Report to the Future Melbourne (Planning) Committee**Agenda item 6.1****Ministerial Planning Referral: TPM-2022-18
28-38 Pearl River Road, Docklands****6 June 2023****Presenter:** Marjorie Kennedy, Head of Statutory Planning**Purpose and background**

MINISTERIAL PLANNING REFERRAL

Application no:	TPM-2022-18
Department of Transport and Planning no:	PA2201816
Applicant:	Capital Alliance 8 Pty Ltd C/- Urban Planning Collective (UPco)
Owner:	Capital Alliance 6 Pty Ltd
Architect:	SJB Architecture
Address:	28-38 Pearl River Road, Docklands 448-454 Docklands Drive, Docklands
Proposal:	Buildings and works to construct a mixed use multi-level building comprising a residential hotel (serviced apartments and hotel rooms), offices, beauty salon (wellness centre), function centre and bar.
Cost of works:	\$150,000,000
Date received:	30 September 2022
Responsible officer:	Xavier Livy, Principal Urban Planner

Figure 10: Comparison of original (top) and amendment (bottom) ground level activation

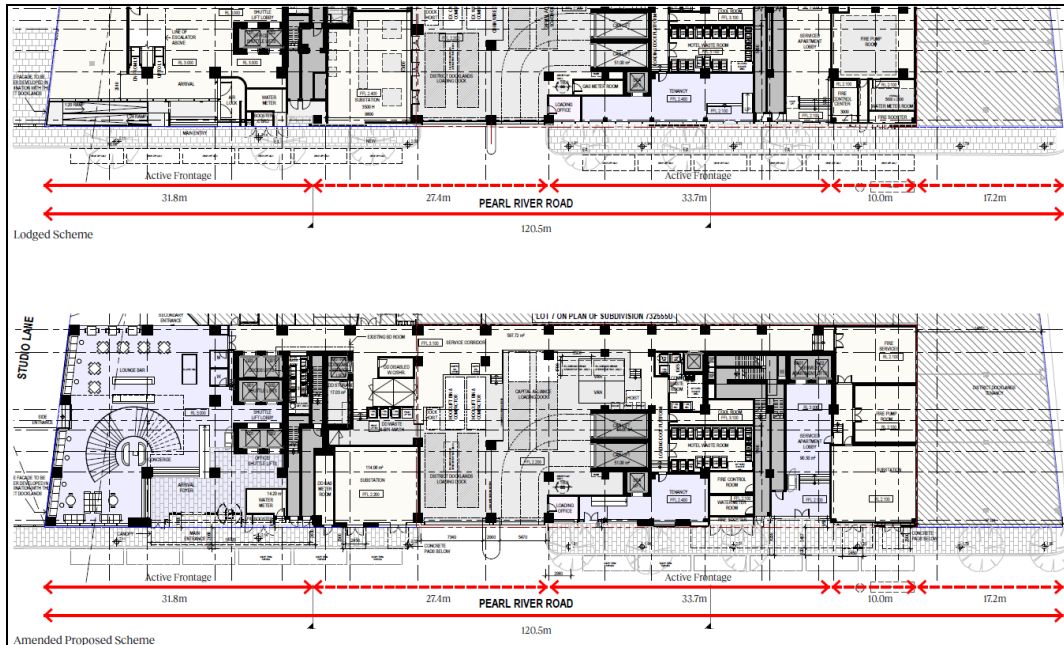
The application was formally amended under Section 50A of the *Planning and Environment Act 1987*. The amended application was referred to Council by DTP on 27 March 2023. The amendment included ground floor level modifications to improve the active frontages to Pearl River Road.

Figure 12: Section of development highlighting the Development Plan Addendum approved envelope

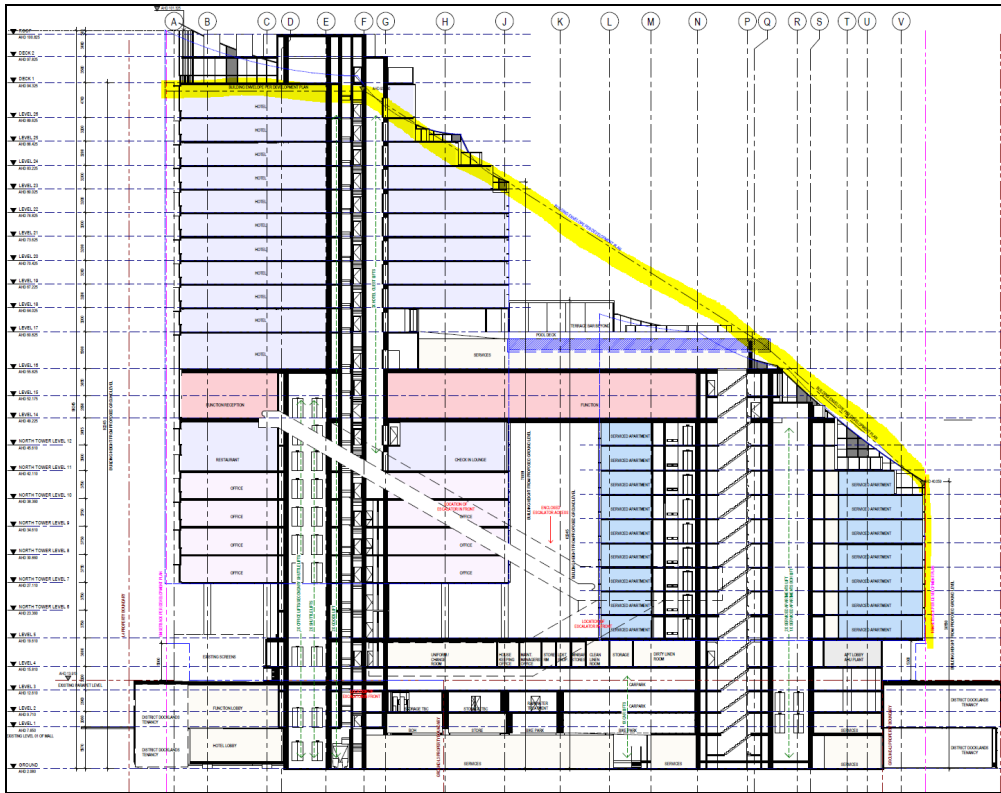
The proposal involves a building with two tower forms that are linked by a function centre, skybridge and escalator. The massing and height generally aligns with the Development Plan Addendum which anticipates an outcome ranging from RL 39.6 to 93.13 metres. The marked up section below depicts (approximately) how the design fits within the building envelope allowed by the Development Plan Addendum.

Level 26 reaches an overall height of 93.1 metres and while there are areas which extend outside of the building envelope associated with the Development Plan Addendum of up to 98.7 metres they are limited to building services, the lift core, plant deck and architectural features such as the glass façade. Furthermore the areas which extend outside of the envelope are of minimal consequence with regard to unreasonably impacting on any existing views within Docklands, from the CBD and the waterfront of Victoria Harbour. It is noted the Development Plan Addendum requires buildings be well designed with obscured plant areas and that any building height should not unreasonably impact on views to and from the Wheel. Therefore the recommendation includes a condition for additional screening to the building services and lift core while ensuring any modifications consider the requirements of the Development Plan Addendum.

Figure 14: Tower setback from Docklands Drive ranges from 8.8 to 11.4 metres.

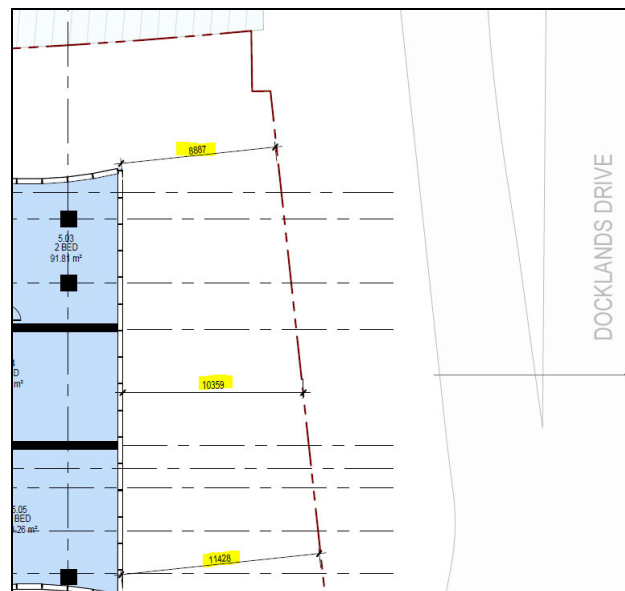
- The southern tower set back ranges from 8.8 to 11.4 metres rather than a consistent 10 metres from Docklands Drive. The outcome is considered acceptable as on average the 10 metre setback is achieved and the 8.8 metre setback is limited to the south eastern corner from Level 5 to 17 only.

Figure 15: Encroachments and links between northern and southern towers

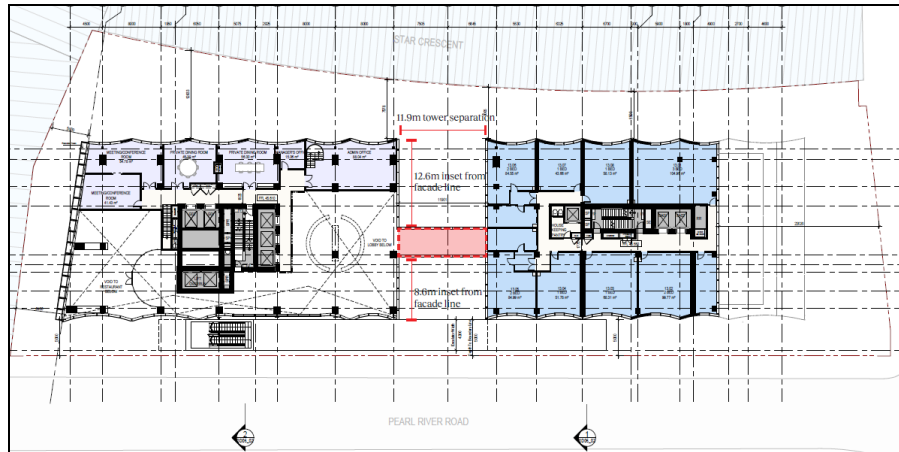
- The proposal includes built form between the northern and southern tower from Level 11 to 17 rather than achieving a consistent 10 metre tower separation. While there is encroachment into this space it does not extend across all levels and is setback further than the tower forms. In addition the towers generally adopt a separation of 11.9 metres which is greater than the 10 metres anticipated by the Development Plan. They also continue to present as two distinct tower forms and the varied setbacks allow for adequate relief when the building is viewed from various points.

Figure 16: Area associated with the escalator compared against building façade.

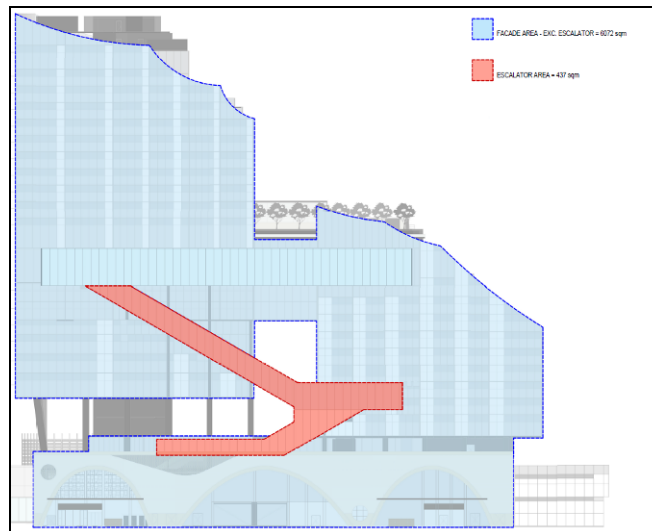
- Provision of an external escalator facing Pearl River Road which extends from Level 4 to 14. The encroachment of the escalator is minor and only accounts for 6.7% (red) when compared against the broader façade (blue) of the building.

Figure 17: Activated frontages and key entry points along Pearl River Road

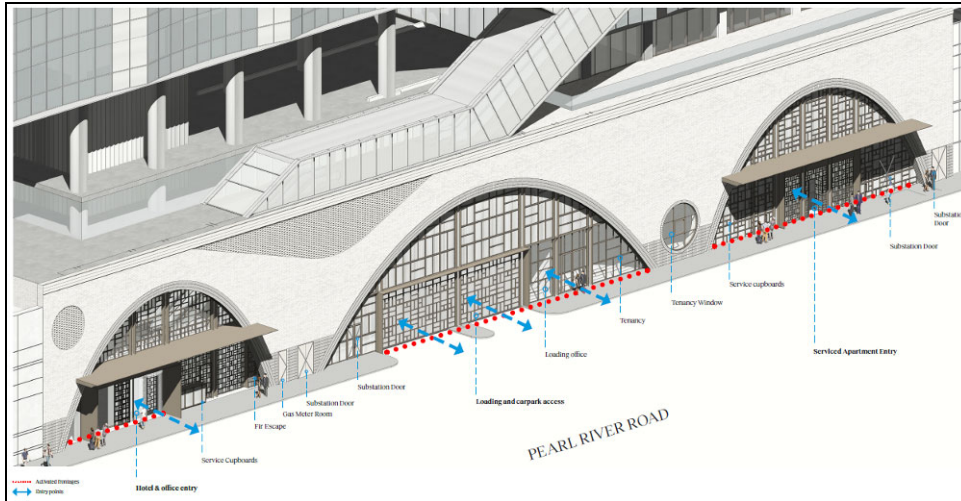
- The ground level proposes active uses and glazing along the ground level interface which seek to encourage pedestrian activity and movement.
- The design includes a length of 65.5 metres of activated entries, with the remaining areas being required for services and vehicular entries. This is appropriate having regard to the site context, existing conditions and the practical constraints of the Site.

Notwithstanding the above, Council’s Urban Design team raised that further efforts must be made to the proposal to achieve design excellence. Therefore the recommendation includes the requirement for a detailed façade strategy which seeks to ensure further efforts are made particularly to the function centre and escalator projections which project into the setbacks stipulated within the Development Plan Addendum.

Figure 20: Comparison of Development Plan Envelope (blue) against proposed shadow at 3pm, 22 September equinox.

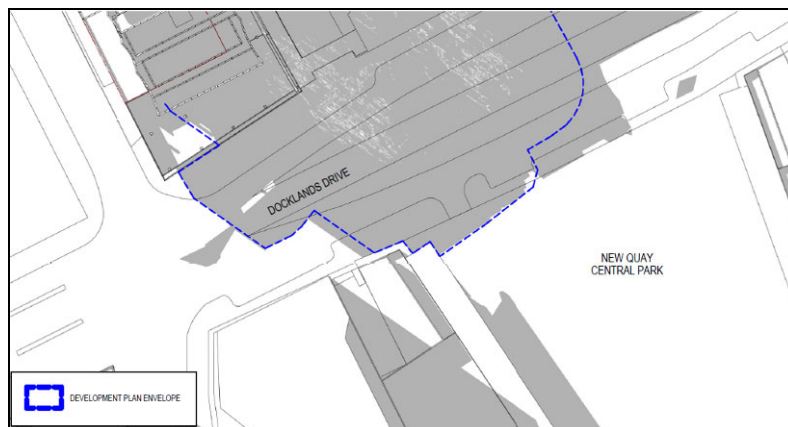
A shadow analysis provided by the permit applicant indicates there is no additional shadow to the New Quay Central Park beyond the shadow diagrams within the Development Plan Addendum.

The shadow diagram provided by the permit applicant show the approved 'Development Plan Envelope' juxtaposed against the proposed building shadow. The diagram confirms the proposal results in no additional shadow to New Quay Central Park as depicted below.
